LAKE TIMBERLINE DAM

NDI No. PA00977
PennDER No. 58-125
Dam Owner: Richard O'Reilly

PHASE I INSPECTION REPORT
NATIONAL DAM INSPECTION PROGRAM
PACW 31-81-C-001

Lake Timberline Dam, Susquehanna County, Pennsylvania
NDI No. PA 00977, PennDER No. 58-125
Tributary of Choconut Creek
Inspected 30 March 1981

FIELD SKETCH
LAKE TIMBERLINE DAM
NDI NO. PA00977
PENNDEER NO 38-125
SCHEMATIC - NOT TO SCALE

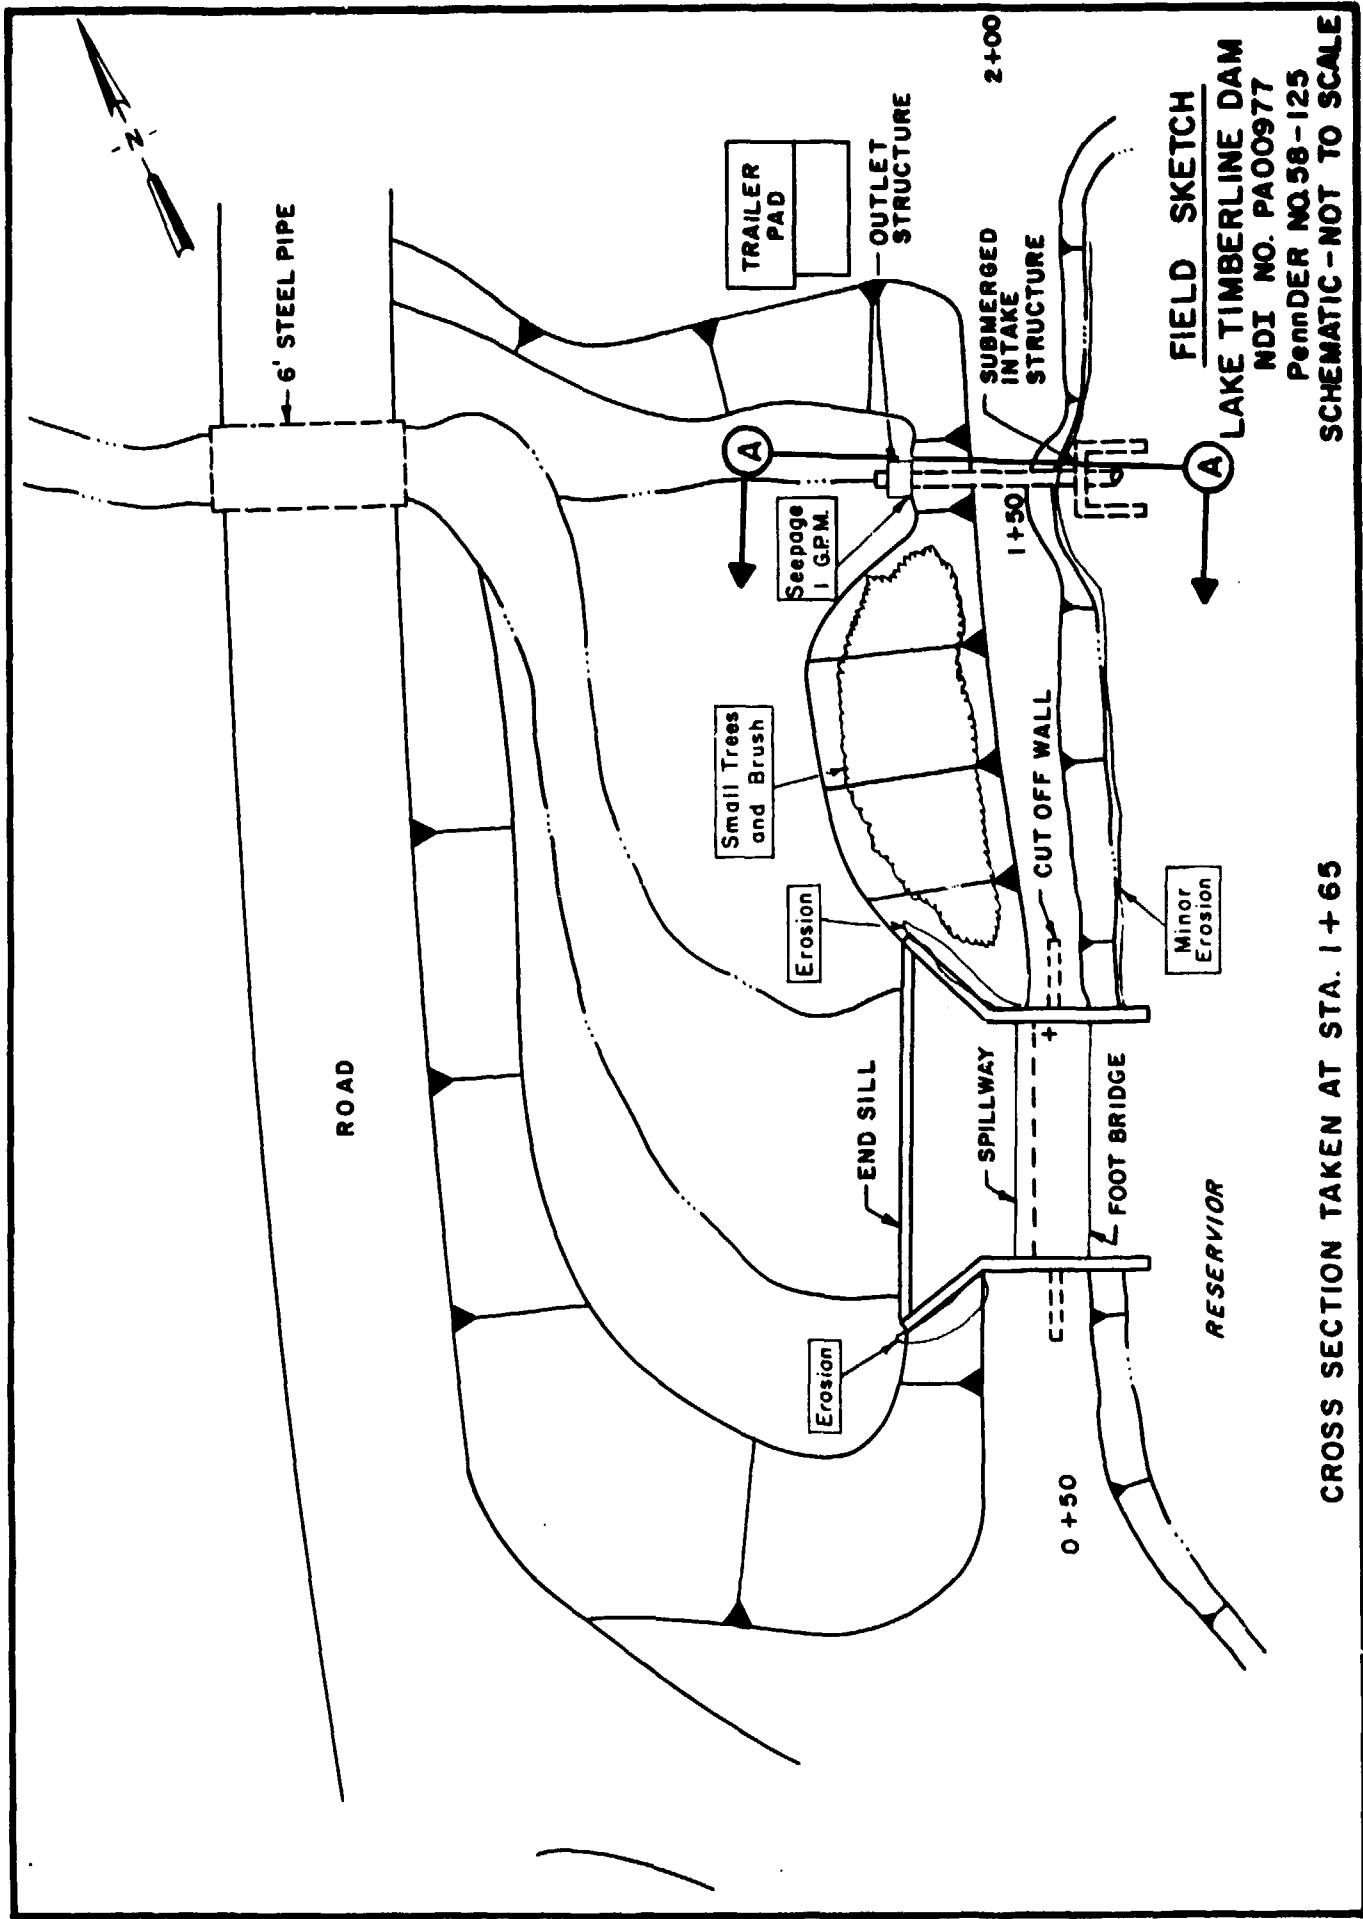
Erosion around both downstream ends
of the spillway training walls.
Minor erosion along the upstream
face at normal pool level.

There is erosion around both sides of downstream end of training walls. The owner reports installing free training material to relieve pressure on the training walls.

The footbridge is in poor condition. Repair or remove footbridge.

Fill and seed areas of erosion.
Place erosion protection on the
upstream face of the embankment
above and below normal pool
level.

PHOTO 6. Close-up View of Discharge End of Outlet Pipe

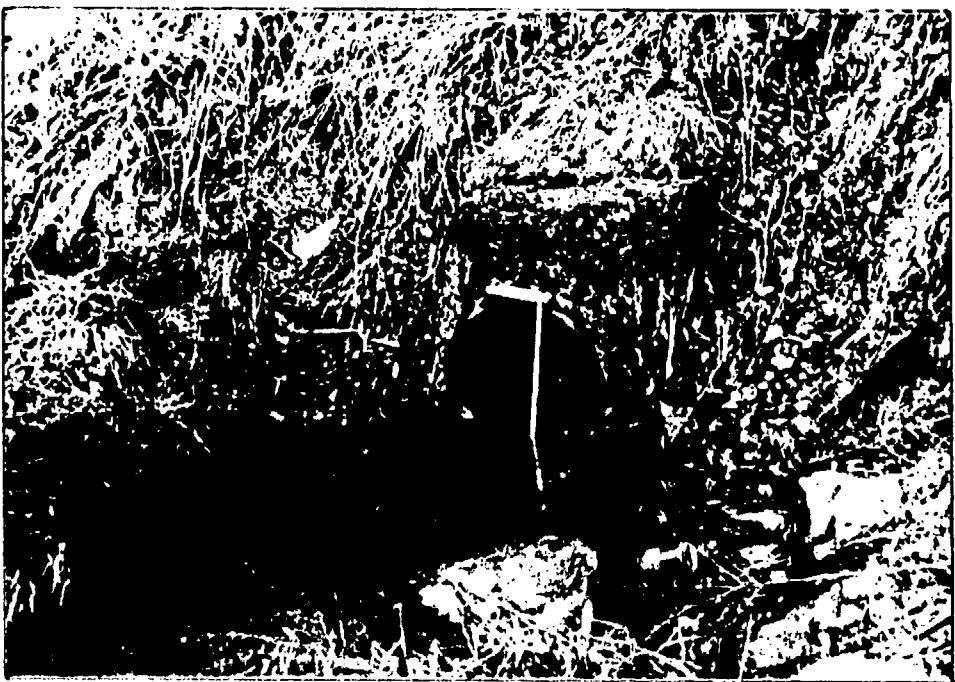
- c. Appurtenant Structures - The concrete headwall at the downstream end of the outlet pipe is deteriorated. The outlet end of the outlet pipe appears to be at a higher elevation than the entrance to the pipe. The foot bridge across the spillway is in poor condition.

- 5) Repair the concrete headwall at the downstream end of the outlet pipe.
- 6) Repair or remove the footbridge across the spillway.
- 7) Cut all trees at the toe of the embankment at ground level. All trees with a trunk diameter greater than 3 inches should have their root systems removed. All resultant areas of erosion and cavities should be filled, graded, compacted and seeded.
